Drainage Improvement Works at Ngong Ping

Approval Environmental Impact Assessment Report (Register No. AEIAR – 169/2013)
Submission for Fulfillment of EIA Approval Conditions

Project Title: Drainage Improvement Works at Ngong Ping (Application No. EIA – 206/2012)

Response to Conditions of Approval (EPD's letter dated 21 April 2013)

**HABITAT MAP
(SHEET 1 OF 2)**

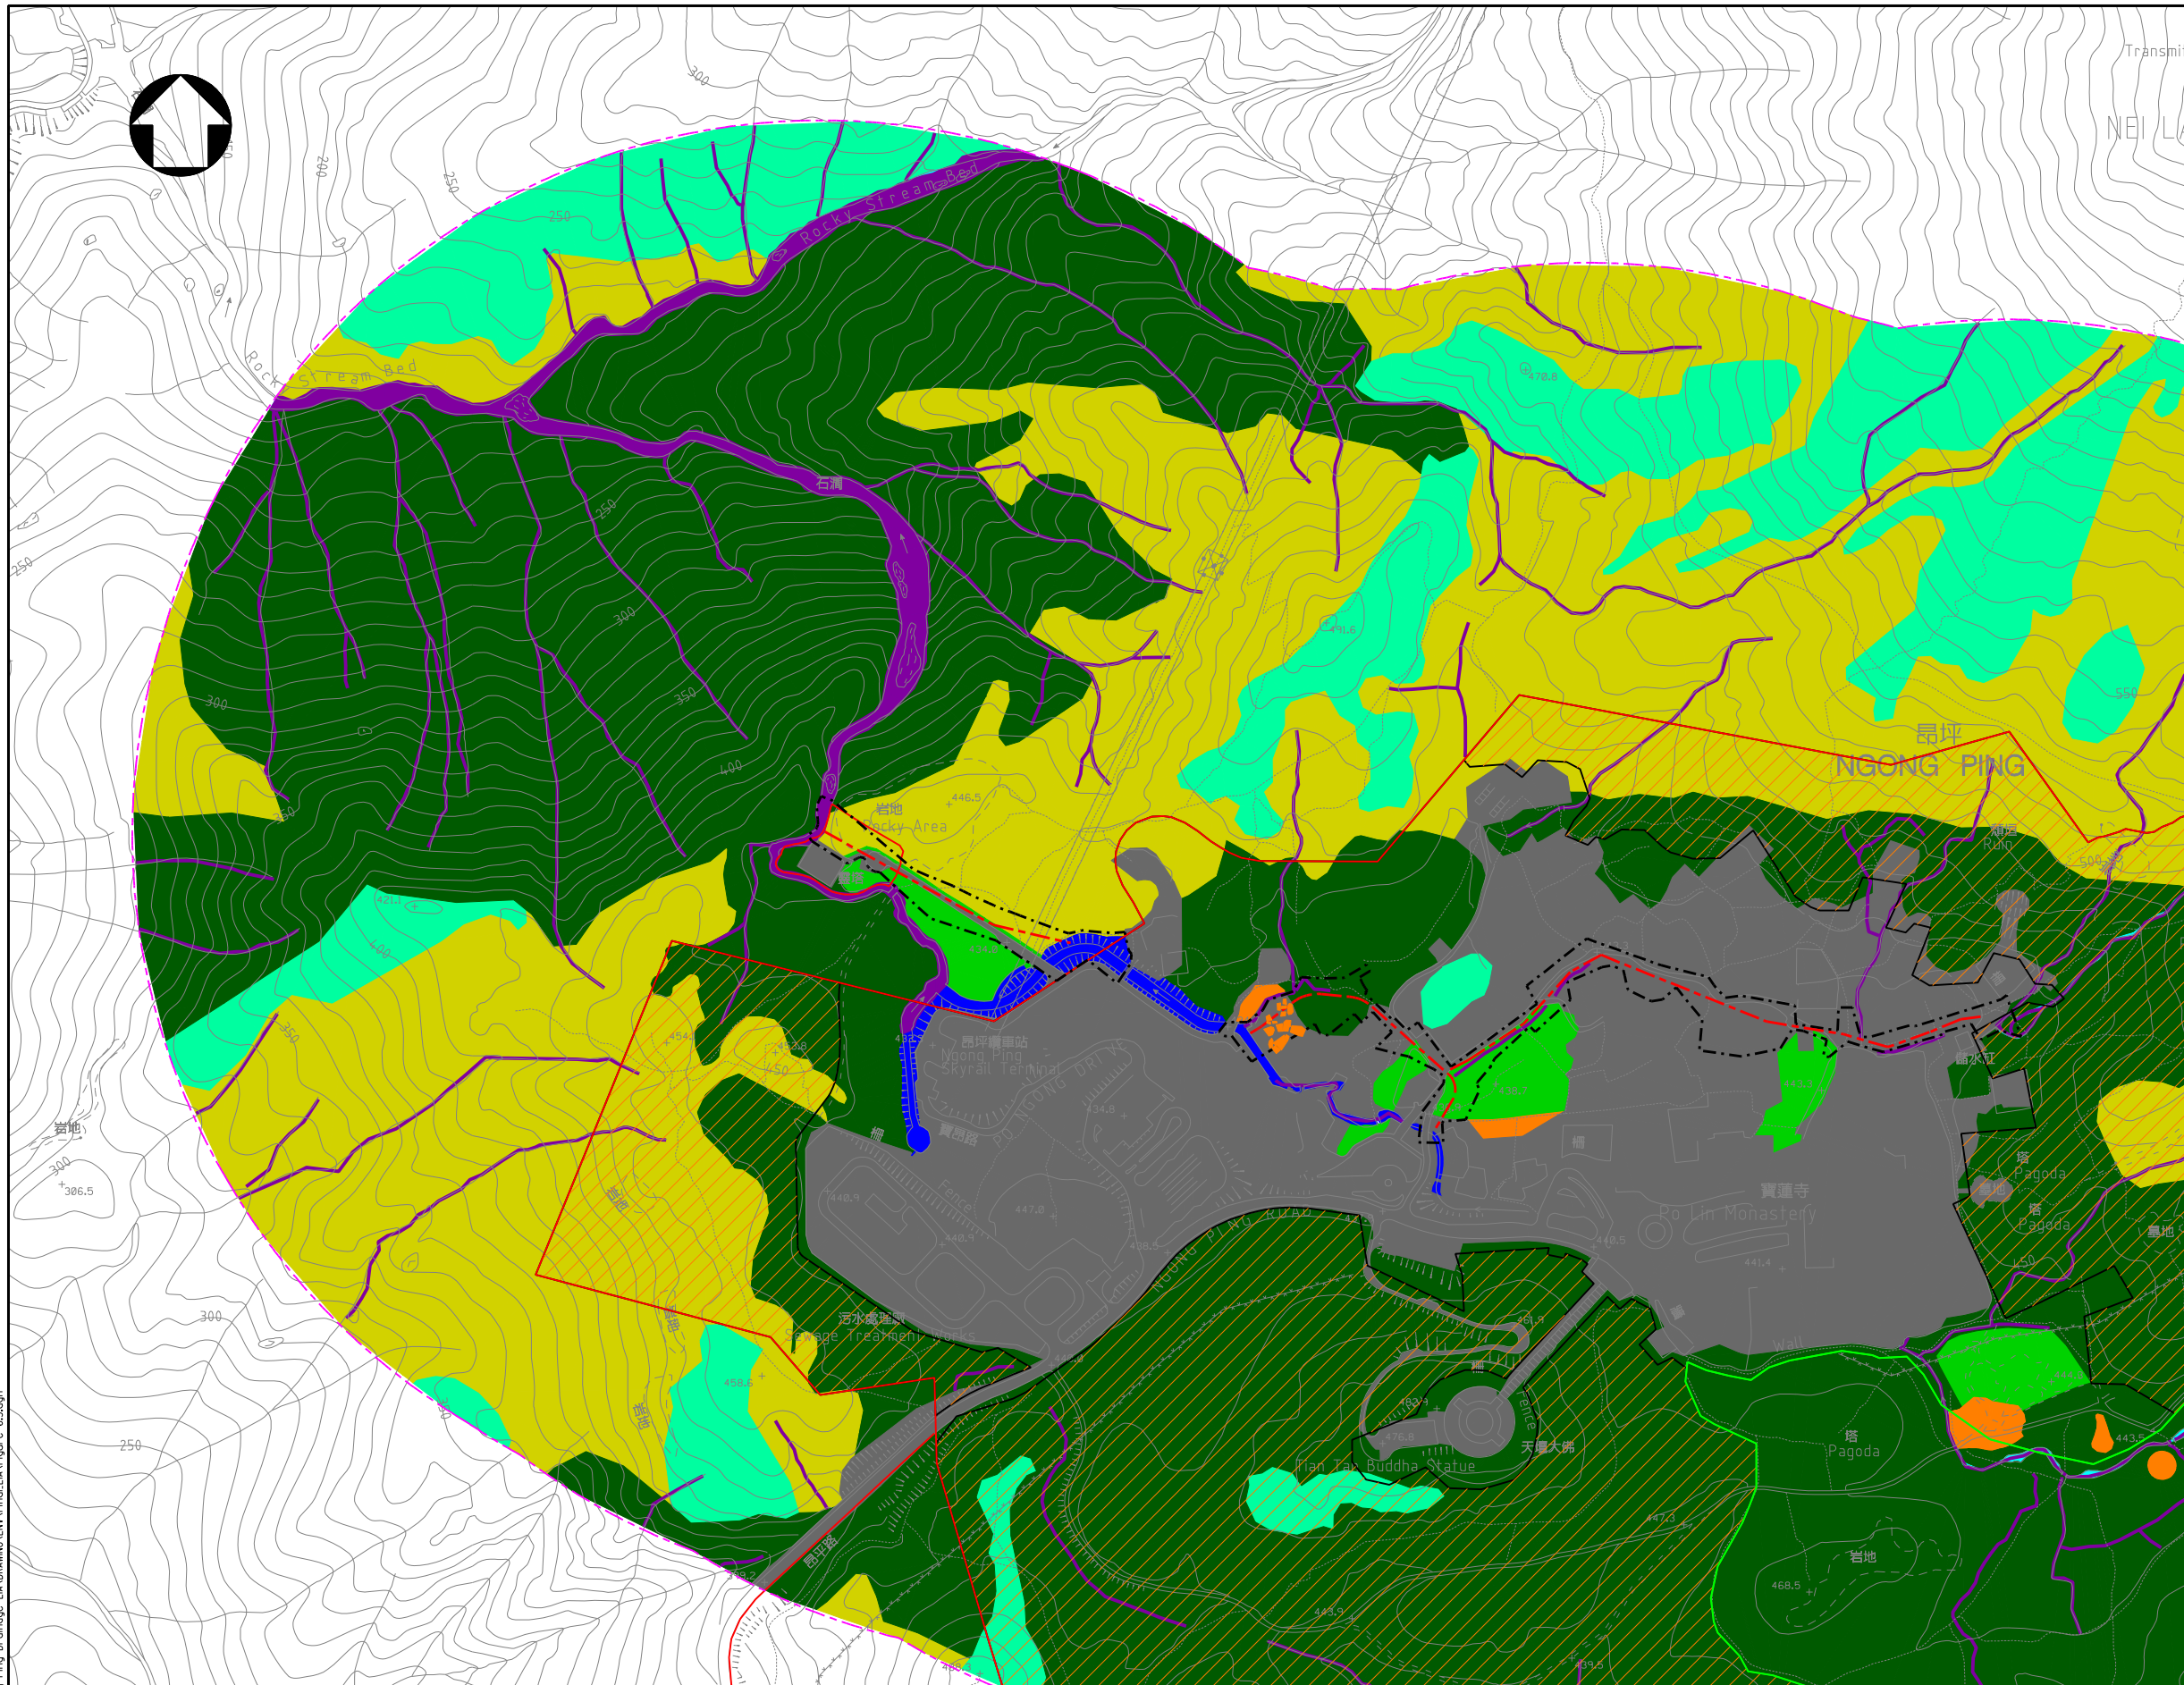
Conditions of Approval	Project Proponent's Response
1. The Project Proponent shall amend the Habitat Maps of the EIA report to include the seasonal streams which were identified and assessed in the EIA report.	The seasonal streams were identified and shown in other figures and assessed in the EIA Report. Please refer to Annex 1 to this response showing the updated Habitat Maps of the EIA report with the inclusion of the seasonal streams.

Amendment to Habitat Maps of the EIA Report

Annex 4a Ground Investigation Plan

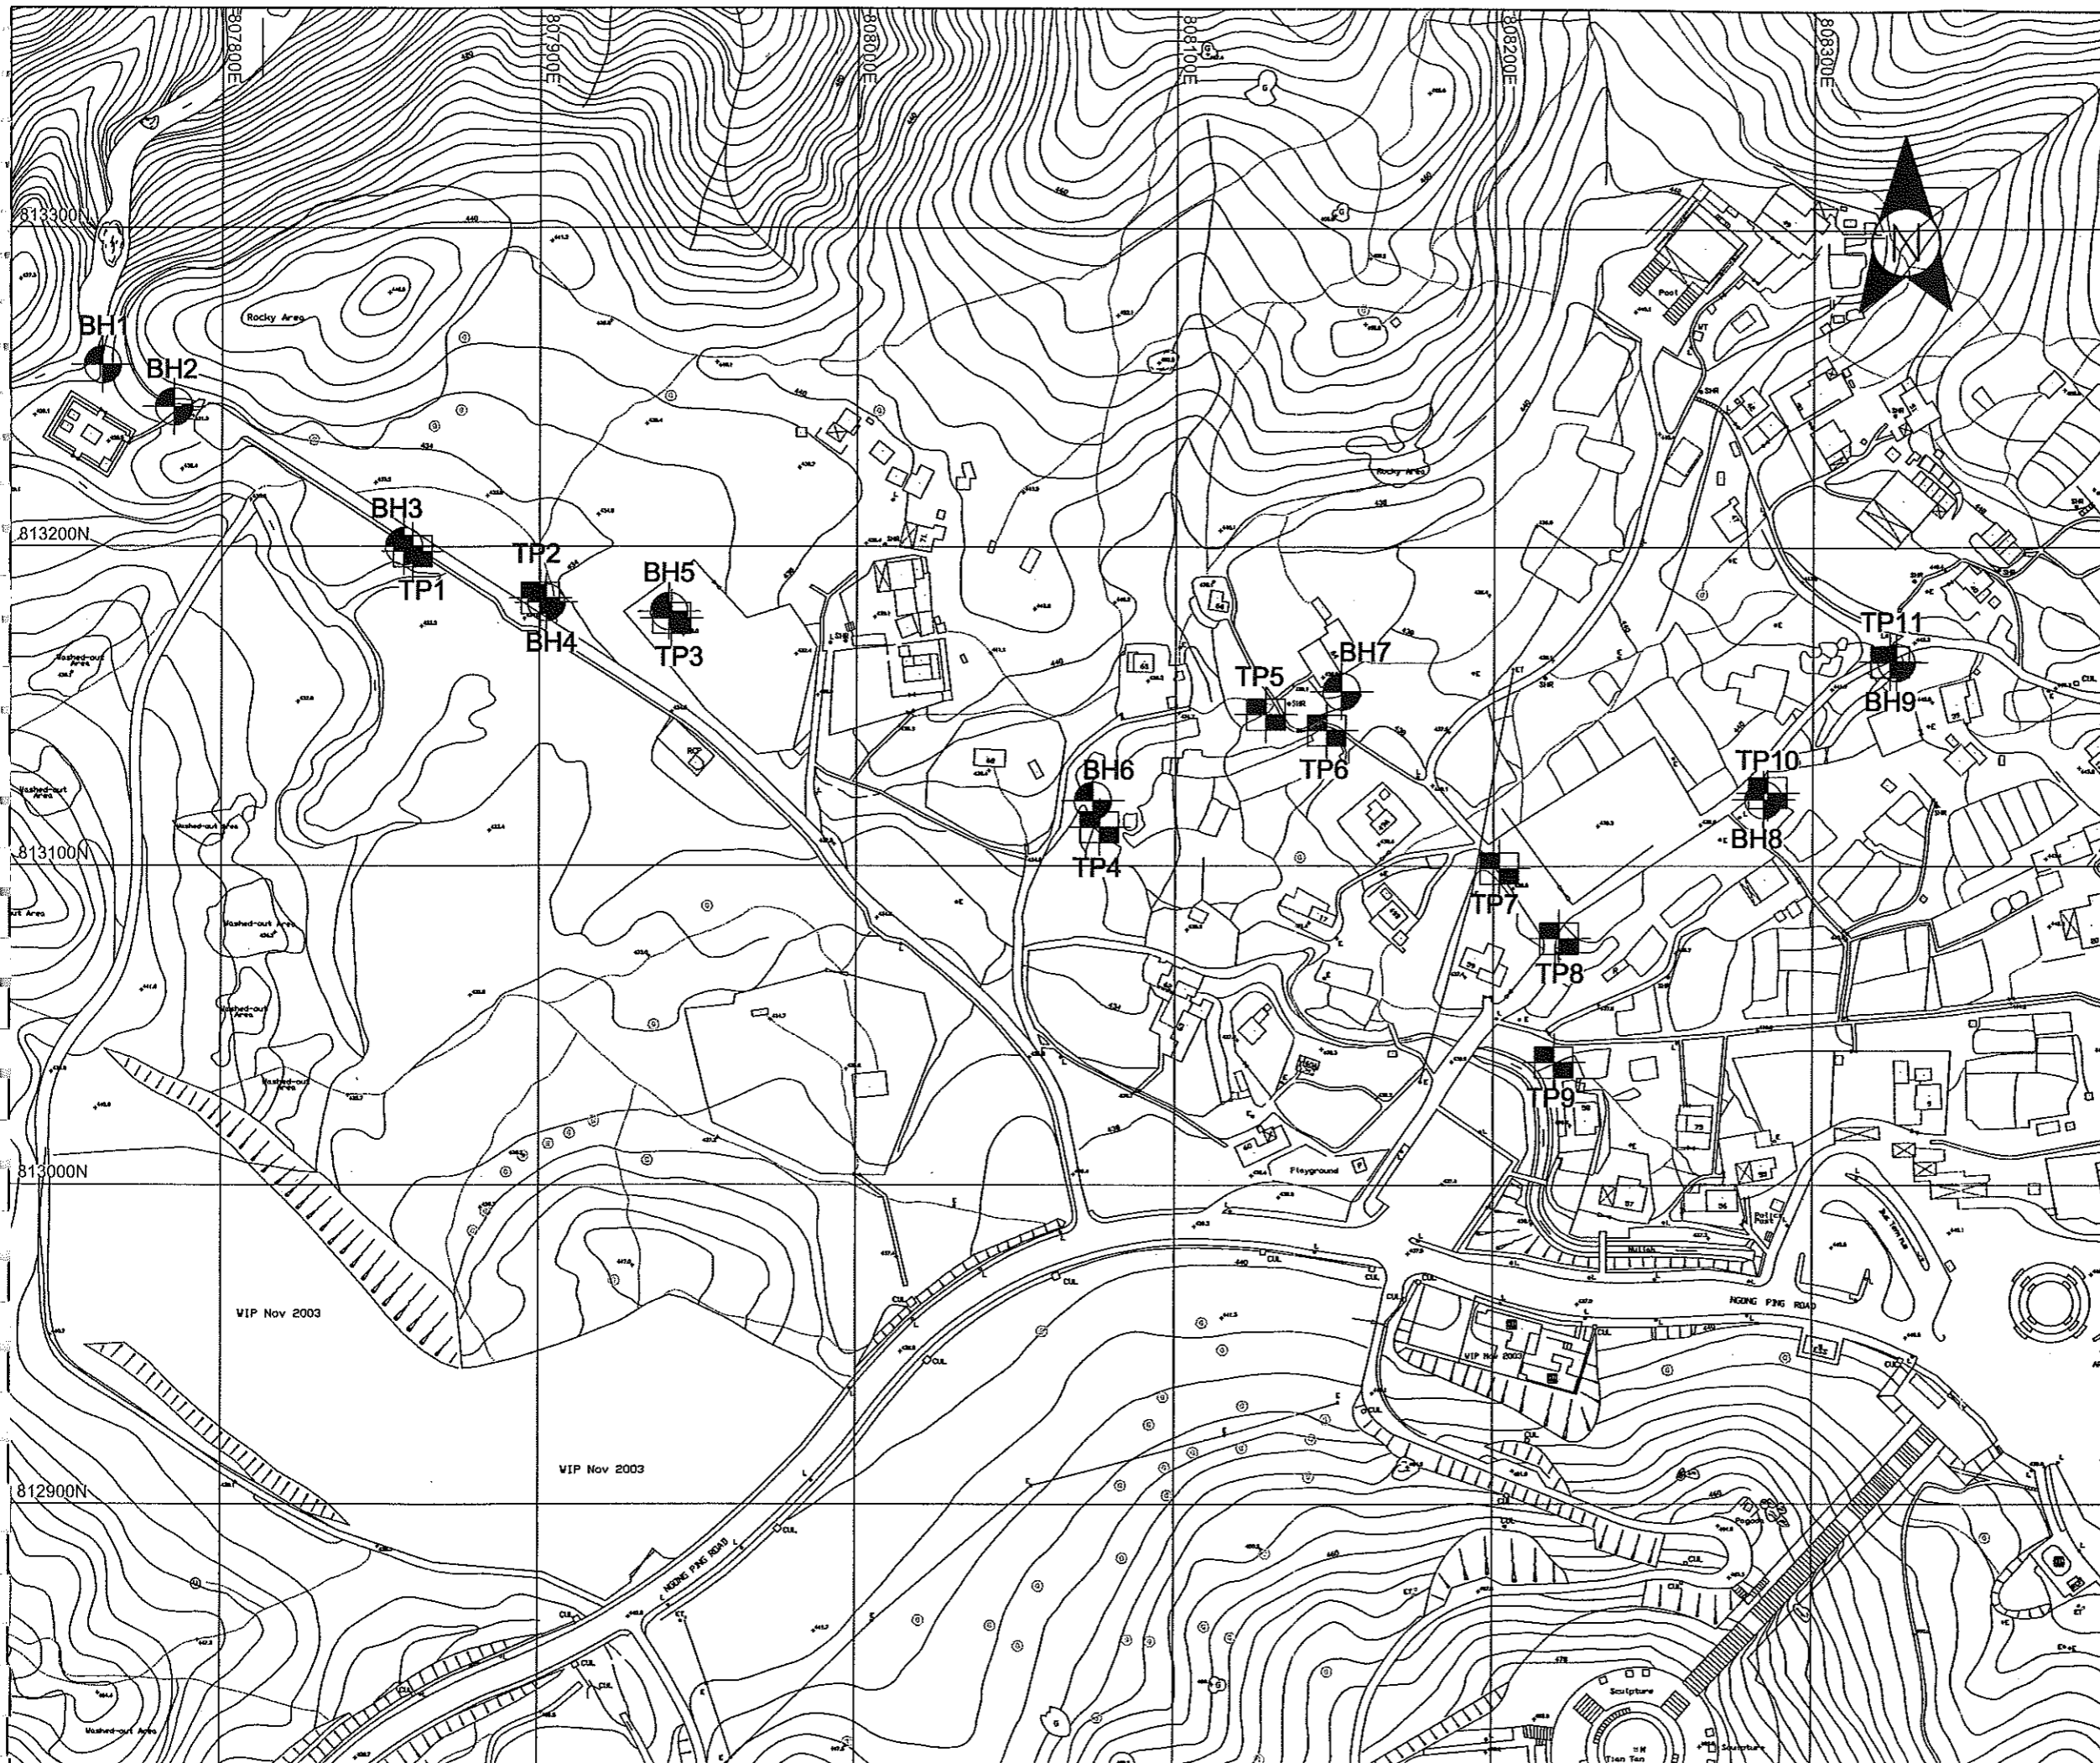
4. The Project Proponent shall amend Section 5.8.3.3 of the EIA report to include the detailed findings of ground investigation works which was carried out for the project.	Please refer to Annex 4 to this response showing the amended Section 5.8.3.3 of the EIA report supplementing the information regarding the ground investigation works carried out for the Project.

Construction site run-off may also be generated from the excavated trenches or pits. In this Project, ground investigation (GI) works were conducted between November 2011 and February 2012 to examine the underground conditions including the utilities locations and soil / ground-water conditions. The GI plans are shown in Annex 4a. Field testing for ground-water measurement was also made at 11 drillholes (BH1, BH3, BH4, BH5, BH6, BH7, BH8, BH9, BH11, BH12 and BH14) along the drainage alignment and only 4 (BH4, BH7, BH9 and BH14) out of the 11 drillholes were identified with ground water (at a depth ranging from approximate 4m to 12m below ground level). Thus, infiltration of ground water to the pits/trenches will not be substantial. On the other hand, the underground pipe jacking works which are to be aligned at about 4m - 6m below ground level, involve only the construction of diameters 1.5m and 1.8m concrete pipes where the ground water (even if presence) can easily flow along the surface of the pipes owing to the small pipe size and will not be cut-off. Therefore, the proposed pipe jacking works will not alter the water table and the hydrology in the vicinity. As regard the site run-off from the pits / trenches, it is likely to be generated in the wet season during periods of rain and during watering of the excavation works and surrounding area to suppress dust generation. Despite that the infiltration of ground water to the pits / trenches during construction would not be substantial based on the GI findings, mitigation and protective measures have also been proposed to limit the associated environmental impacts arising from the construction site run-off. The adoption of trenchless method with only the construction of small pits of 4m x 8m as well as the sectional works of about 40m for each cut-and-cover trench could minimize the amount of contaminated runoff generated. Specific mitigation measures have also been recommended in **Section 5.8.8** to reduce the risk of contaminated site-runoff from polluting the existing watercourses to an acceptable level.
